HOPE CREEK GENERATING STATION
DOCKET NO. 50-354
NRC REVIEW OF STRUCTURAL/GEOTECHNICAL TOPICS

Attachment: Resolution of NRC Comments on
Structural/Geotechnical Topics

Response to NRC Audit

FIGURE 1: Plot of α - β versus modal damping for soil column, OBE case

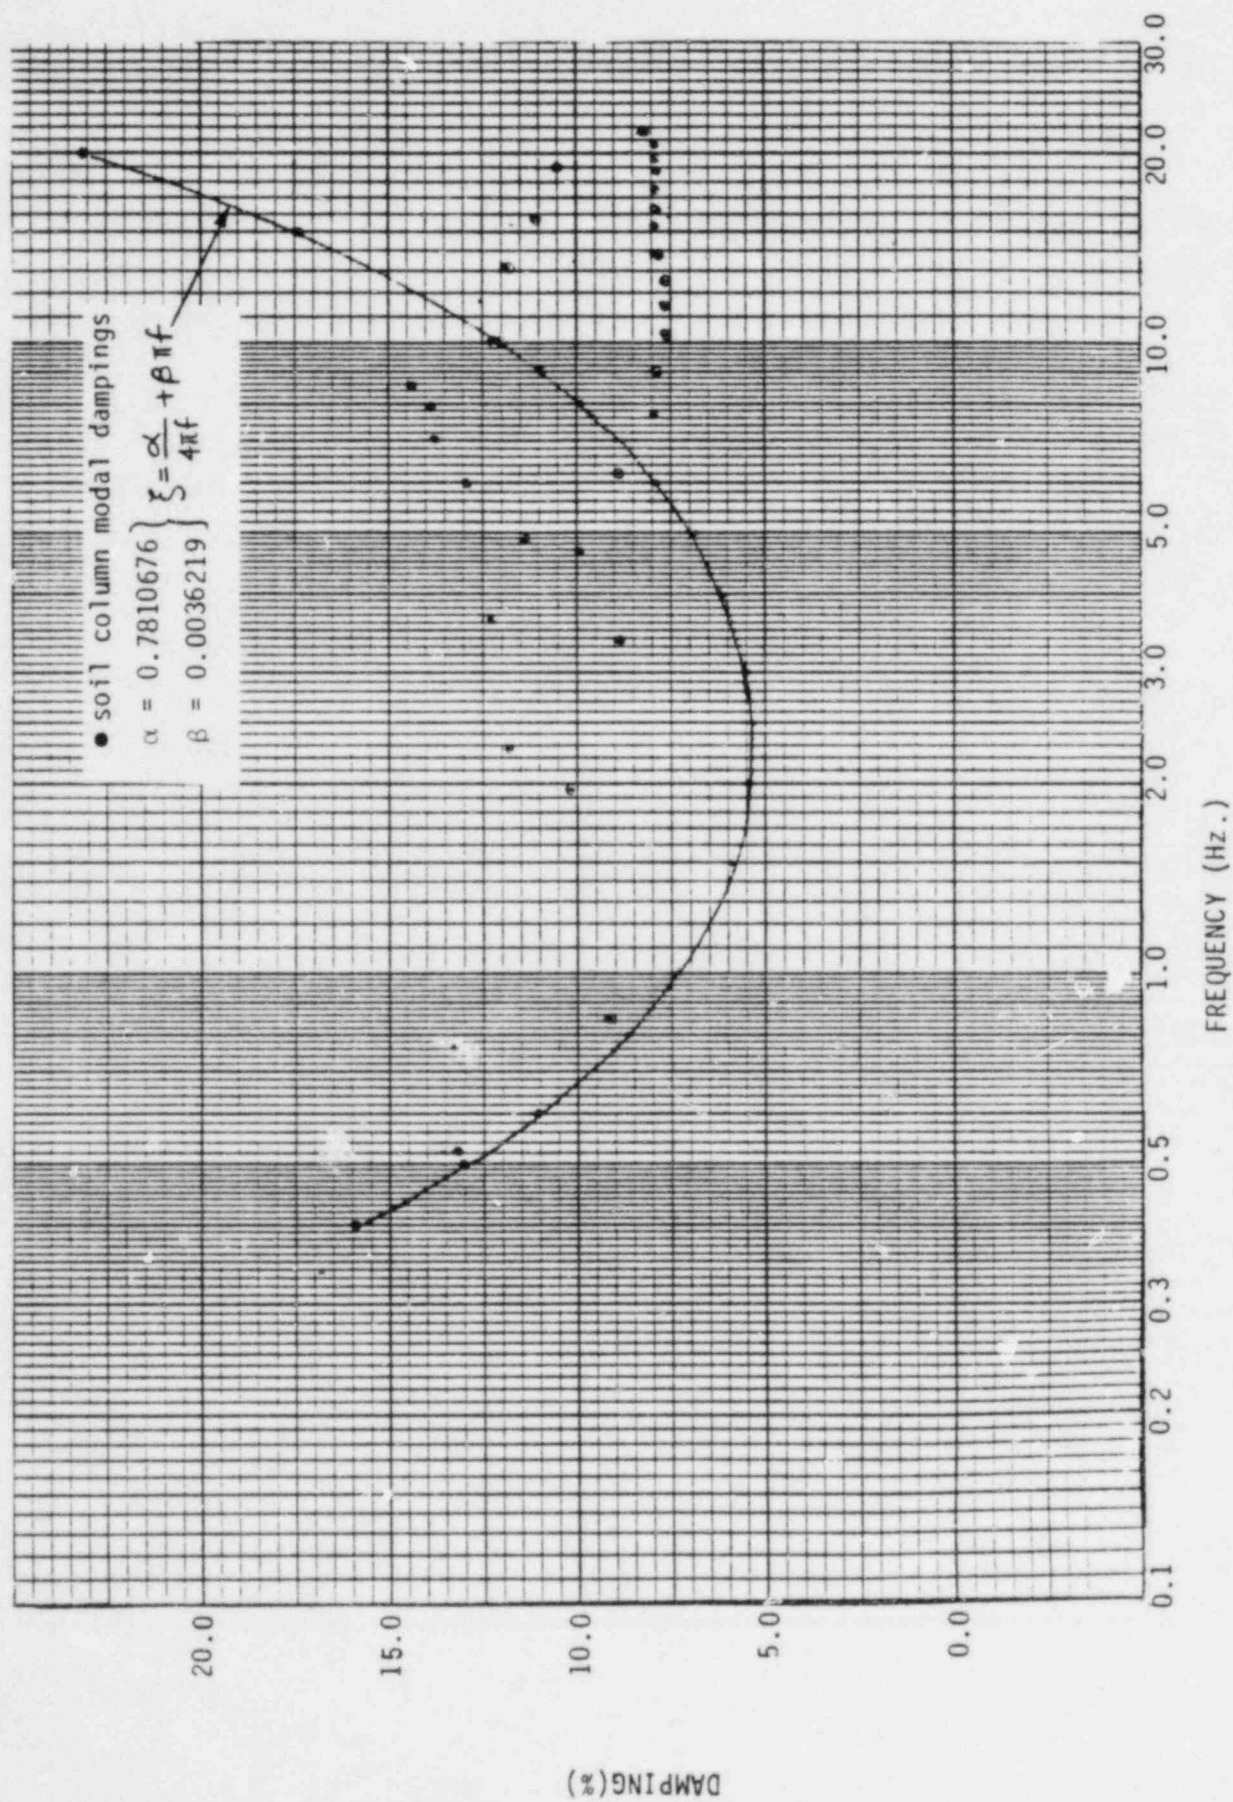
Question: Describe two alternate methods used for establishing soil damping values.

- 2) The EDSGAP program uses Rayleigh Damping ($\alpha - \beta$) technique in the direct step-by-step integration time history method. This technique is described below:

For the soil-structure interaction analysis, the modal damping ratios are determined from the deconvolution soil column model which contains strain-compatible soil dampings. The damping factors α and β are then selected to best fit these damping values. For the Hope Creek site, the Rayleigh damping values were chosen such that the resultant α - β damping curve would predict conservative damping values compared to corresponding modal dampings of the soil column in the frequency range of interest. This is indicated in page 2 of the attachment.

402' Model

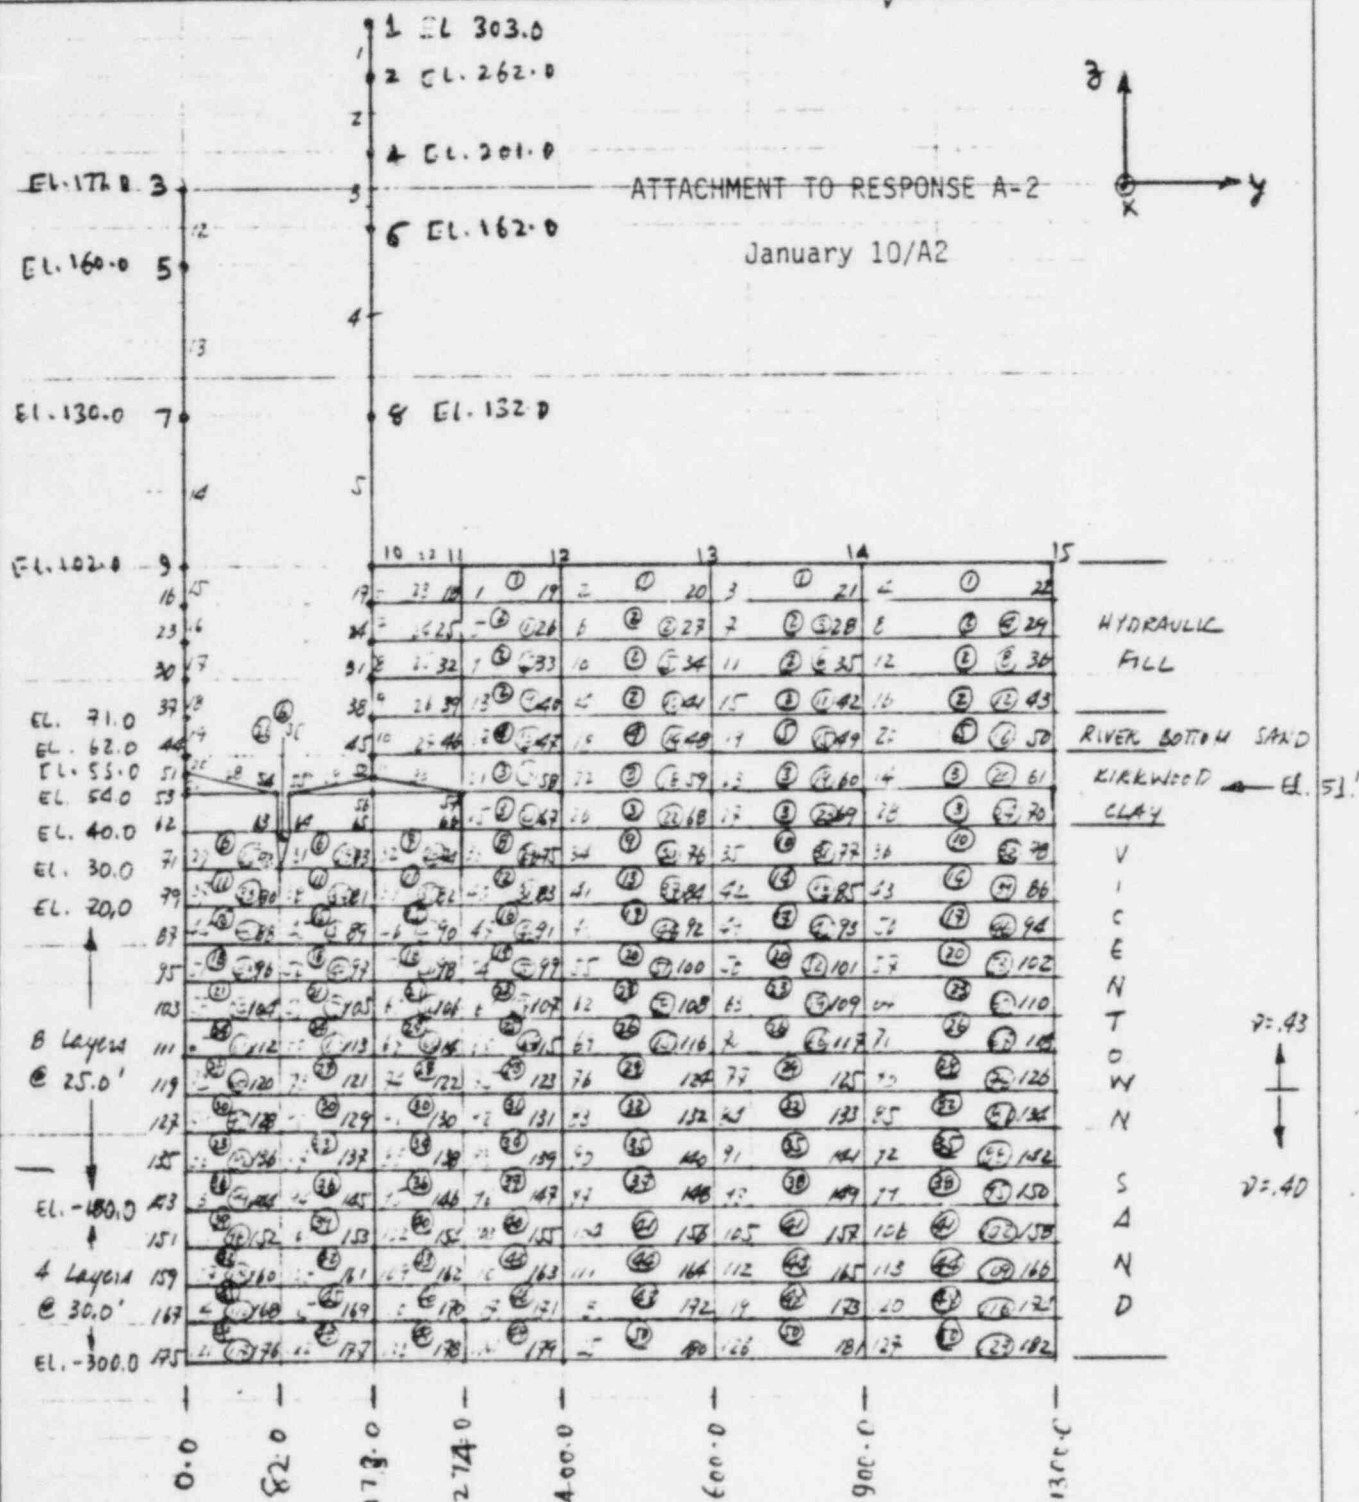
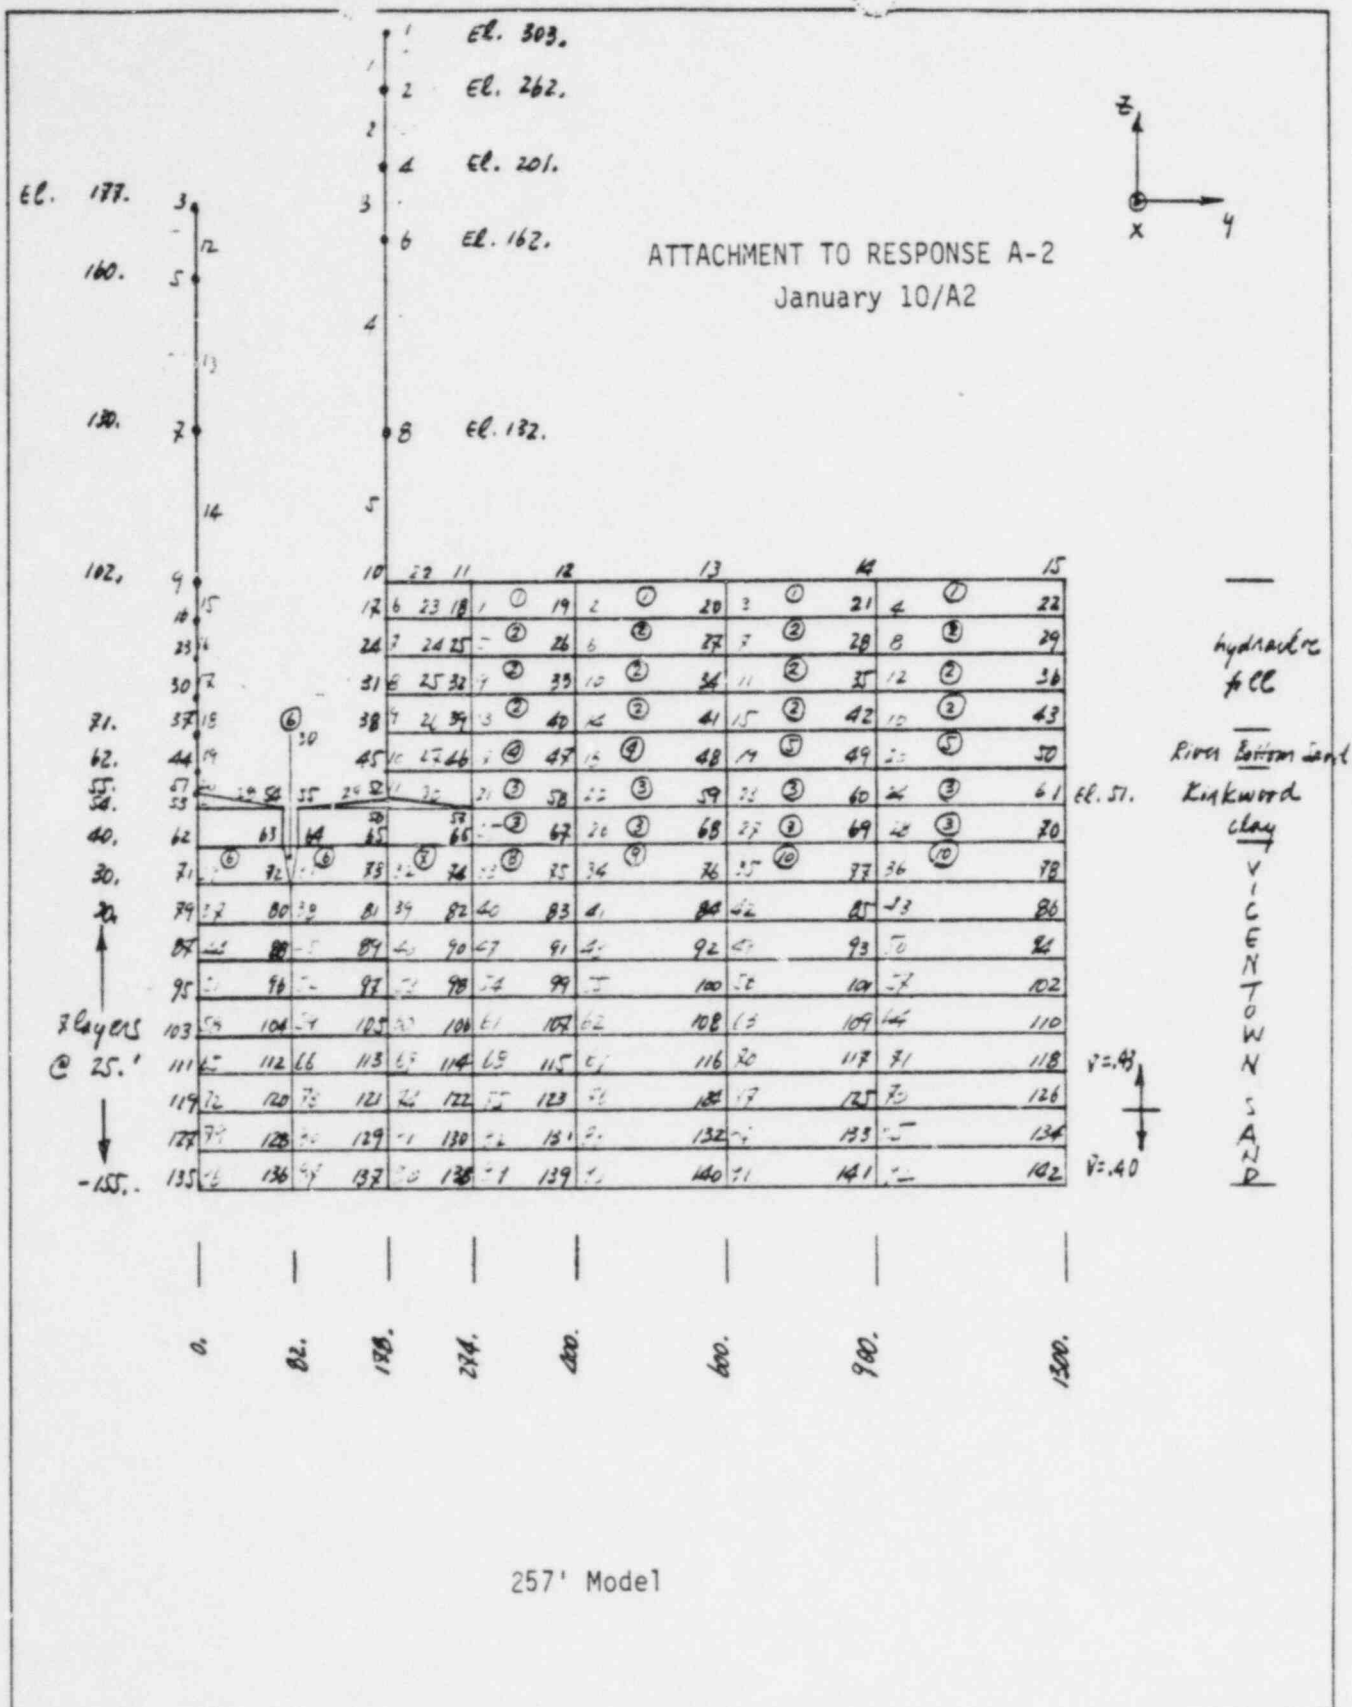
Question: Provide comparison between foundation level response spectra for three soil depth models.

Response: The comparison between foundation level response spectra, as well as finite element representation of the three models in the N-S direction are given in the attachment for the power block area soil-structure interaction depth study. The lateral extent of all three models is approximately 1,000 feet from the edge of the building. A depth of 402 feet was utilized in developing the detailed SSI models for the design basis.

ATTACHMENT TO RESPONSE A-3

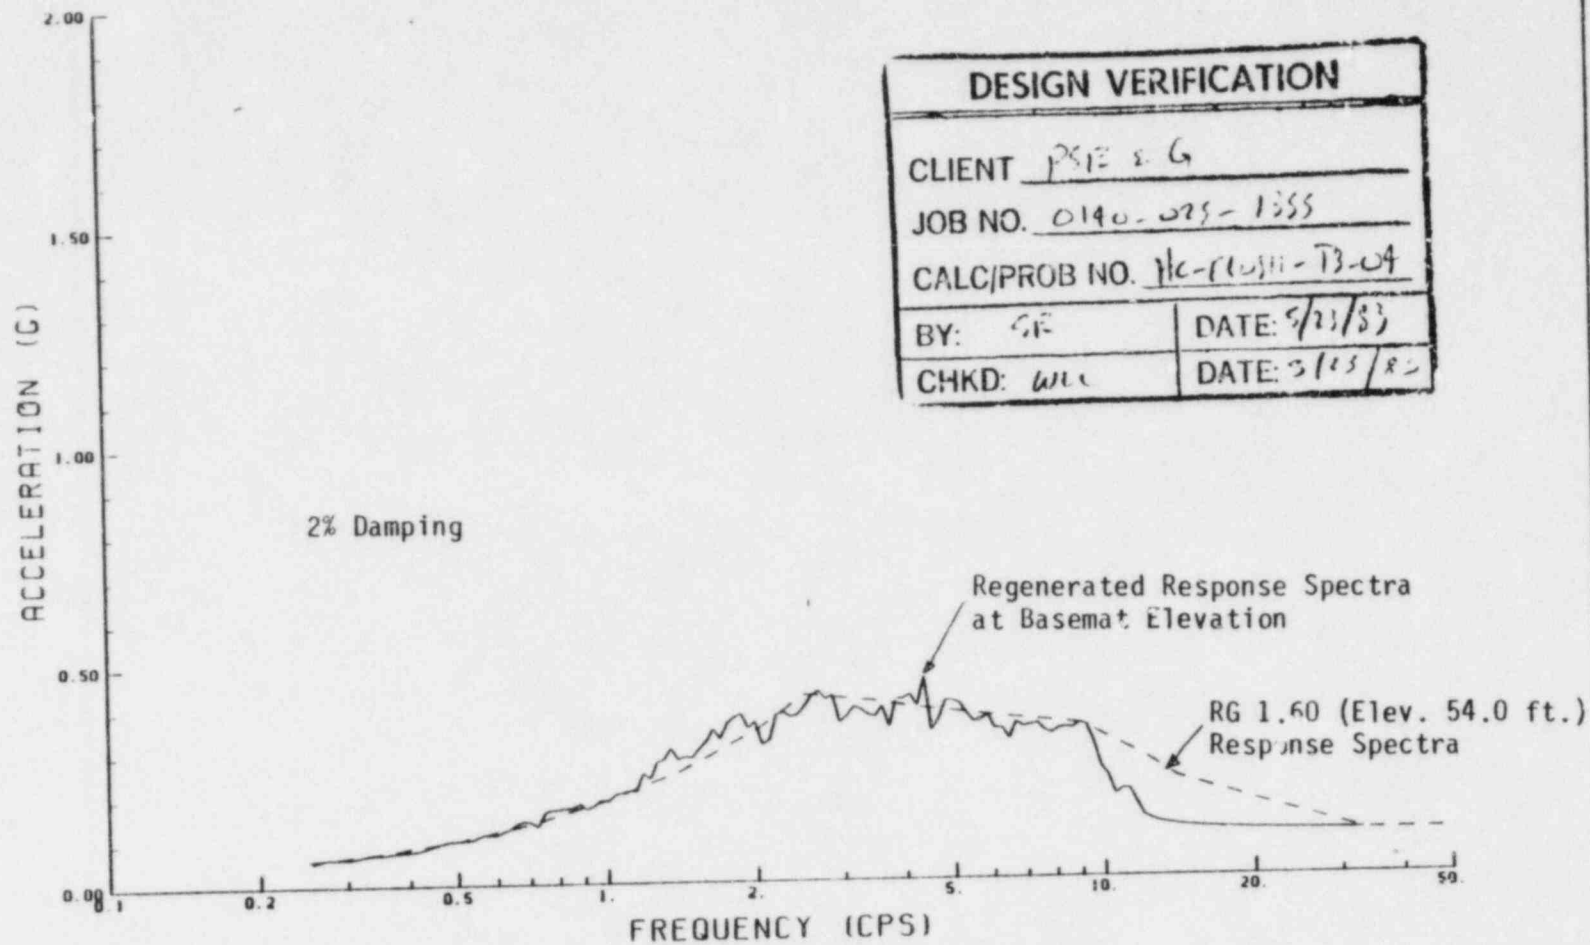
Question: Provide comparison between basemat response spectra and regenerated response spectra at basemat.

Response: The attached two figures provide a comparison between basemat RG 1.60 response spectra and regenerated response spectra at basemat elevation for the horizontal North-South OBE and SSE earthquake soil column deconvolution analyses, respectively.

A 12 Hz cutoff frequency has been used in these analyses. As observed from the attached figures, the match between Reg. Guide 1.60 response spectra and the regenerated response spectra at basemat elevation is adequate below the 12 Hz cutoff frequency. The adequacy of the 12 Hz cutoff frequency is addressed in a separate response to question A-12 from the audit meeting on January 11, 1984.

REACTOR BUILDING VERTICAL FLEXIBILITY ANALYSIS
FINITE ELEMENT PLATE AND BEAM MODEL
FLOOR ELEVATION 145.0 FT.

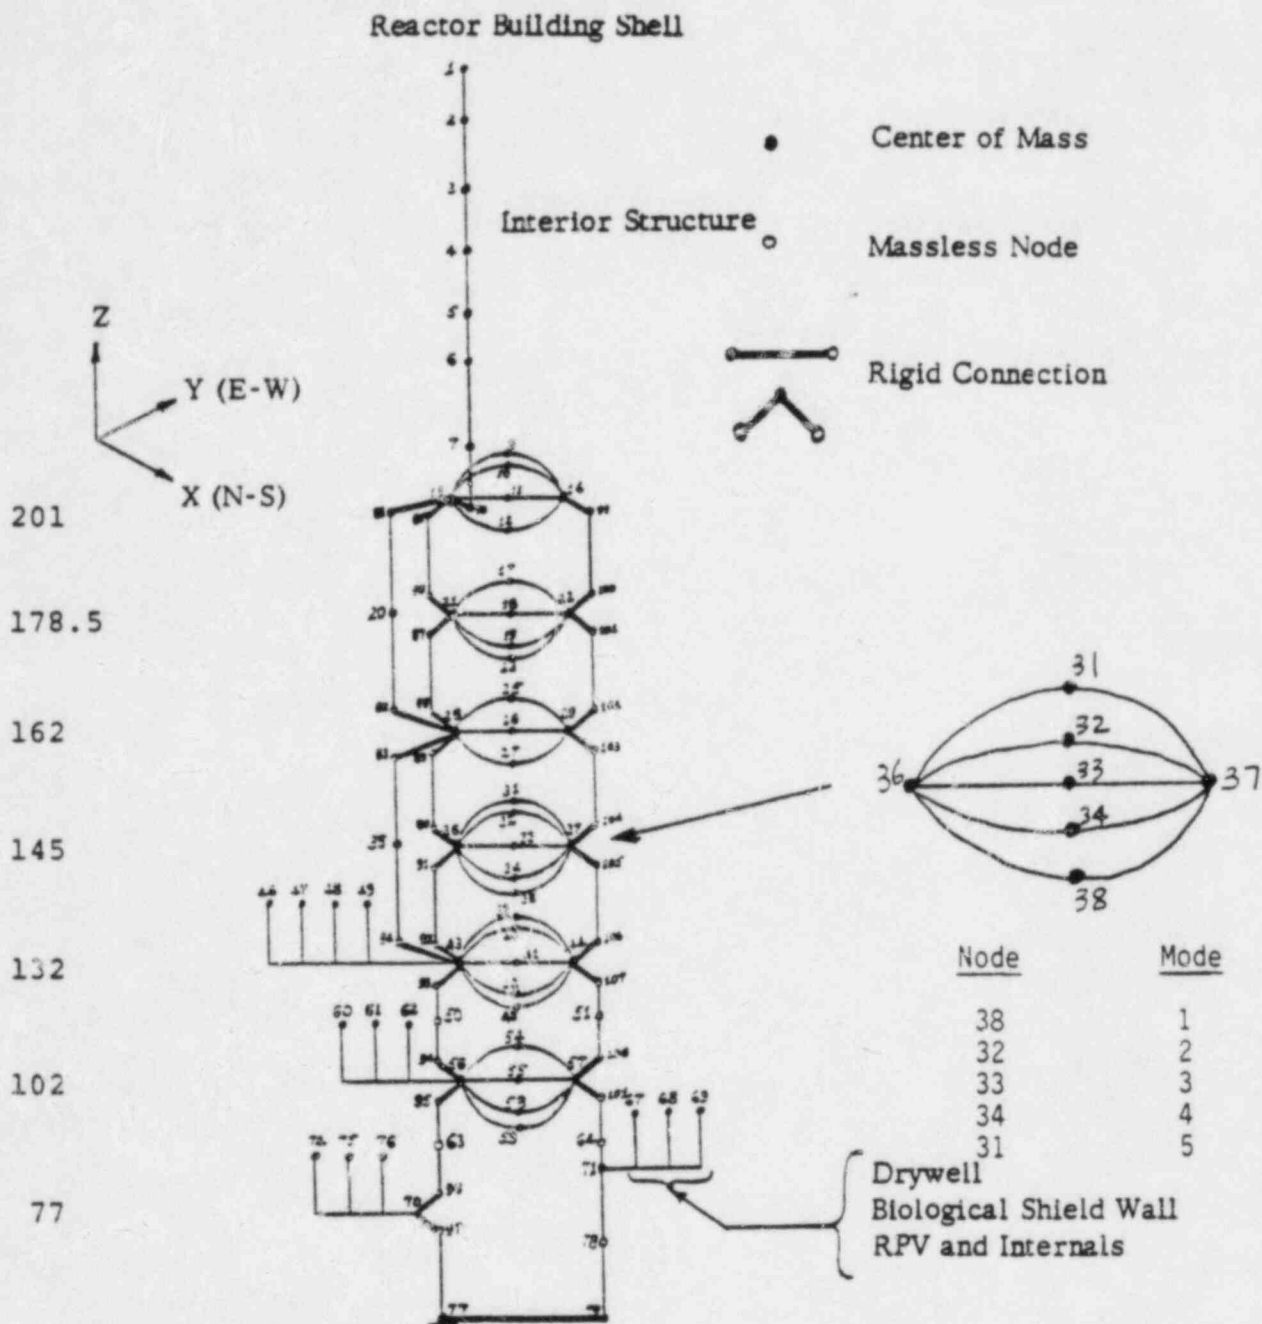
Question: Pick one particular floor to define why particular modes were selected for development of vertical floor flexibility response spectra.

Response: All significant modes below 25.0 Hz were selected from the finite element model of the floor slab for development of vertical floor flexibility response spectra. In general, three to five modes were included with each mode representing a particular region of the floor slab.

For the Reactor Building floor slab at elevation 145.0 feet, five modes were used. Based on the mode shapes of these modes, these modes were determined to represent five different regions of the floor slab, as shown in Figure 1. These five modes were represented by five single-degree-of-freedom beam elements in the vertical floor flexibility model shown in Figure 2.
